SUBJECT: MARK I CONTAINMENT EVALUATION PROGRAM--
IN-PLANT SAFETY/RELIEF VALVE TEST

IN-PLANT SAFETY/RELIEF VALVE TEST

Figure 10. Location of Pressure Transducers in Safety/Relief Valve Discharge Line

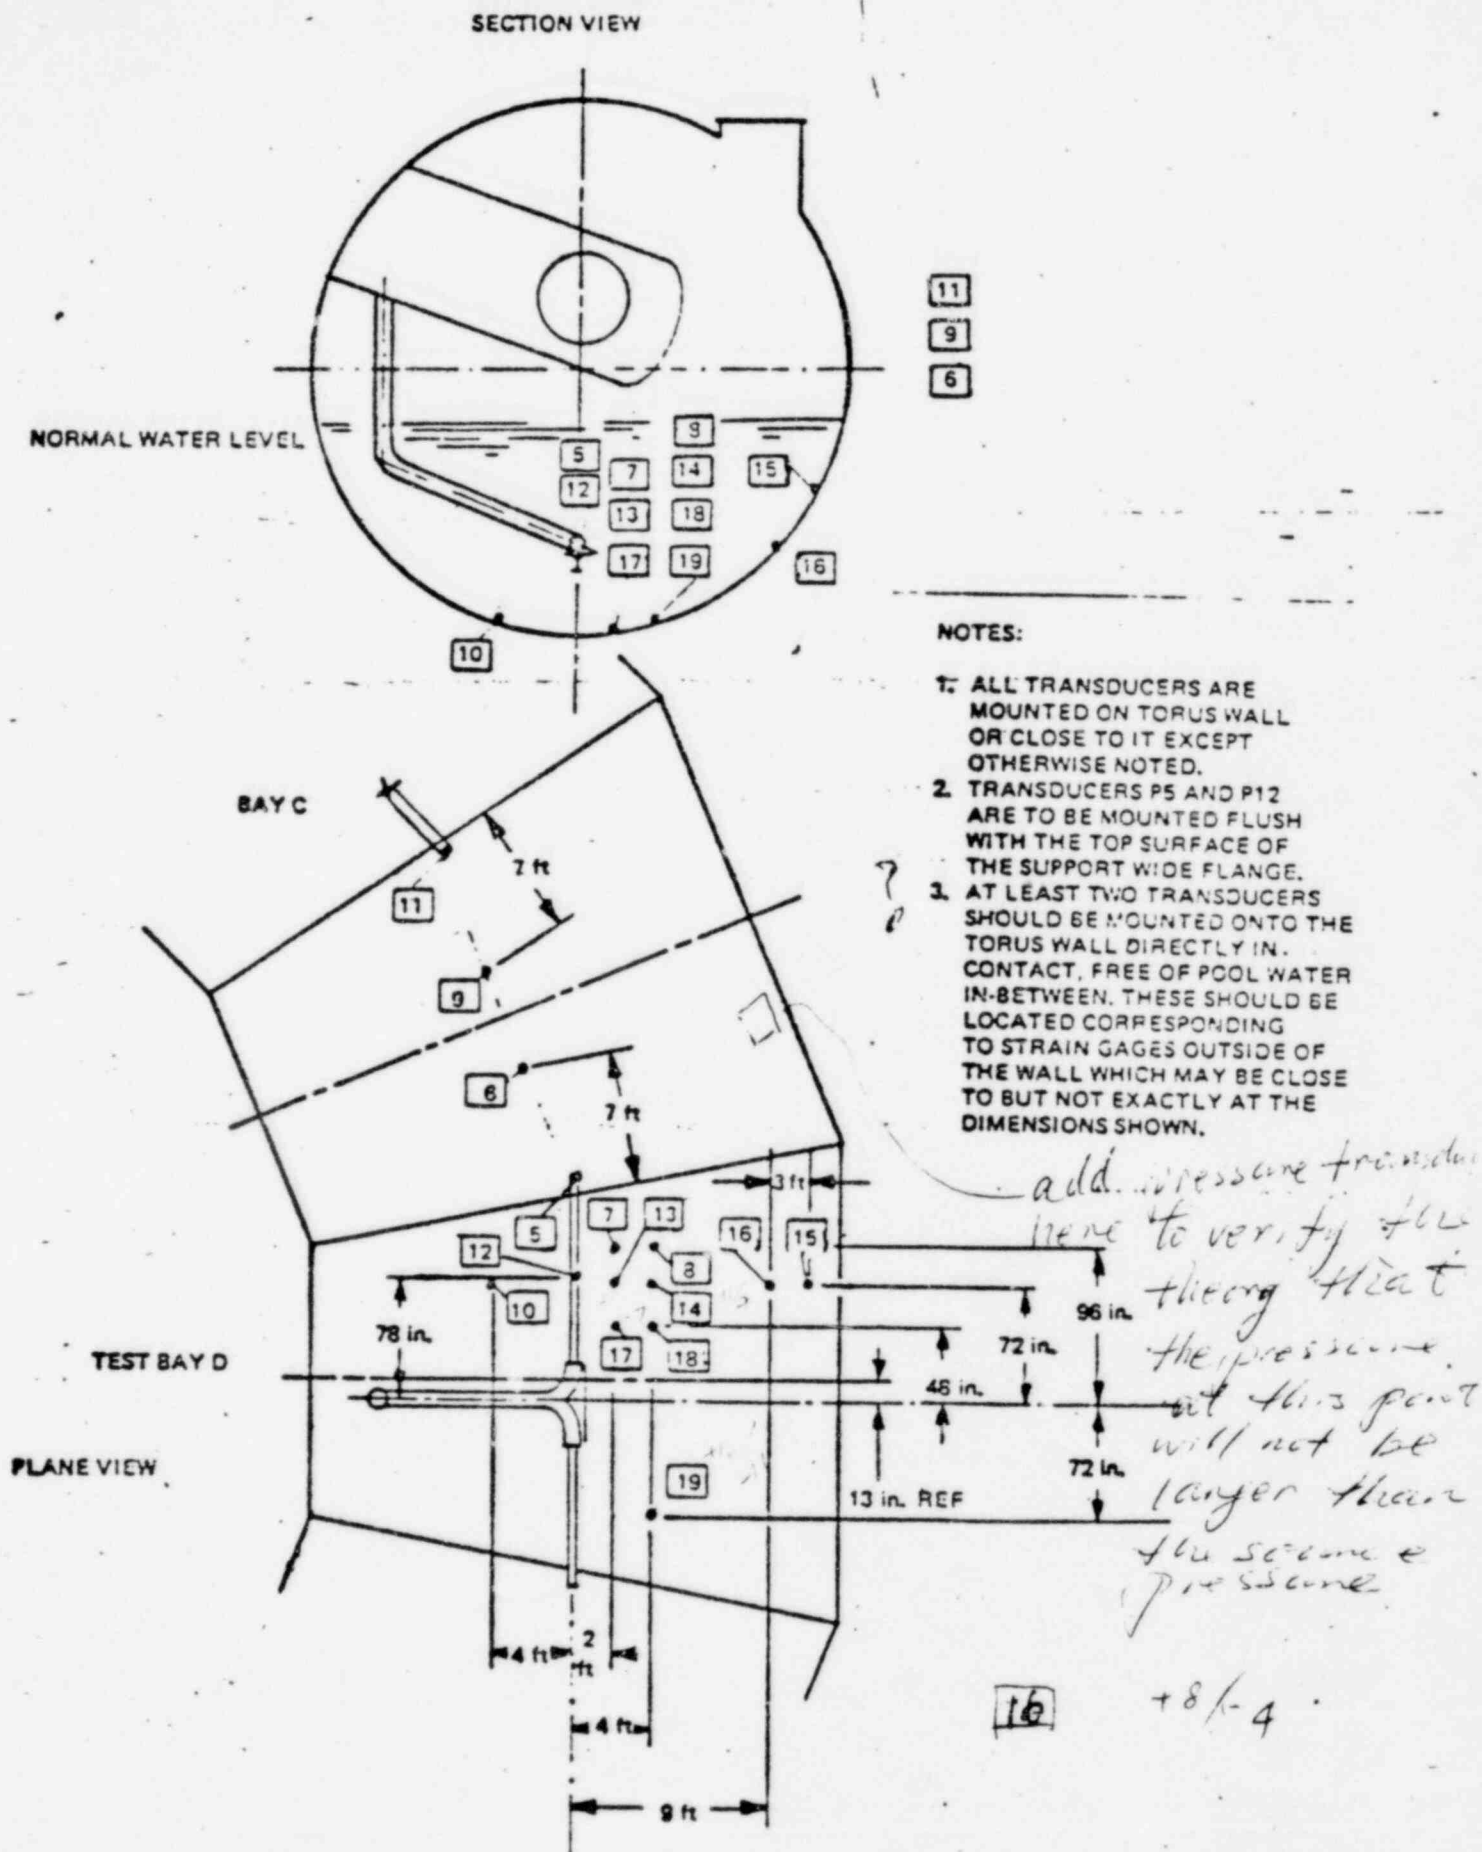
Test should be conducted on the following geometric

Duome Arnold & others

$$L_1 > L_2$$
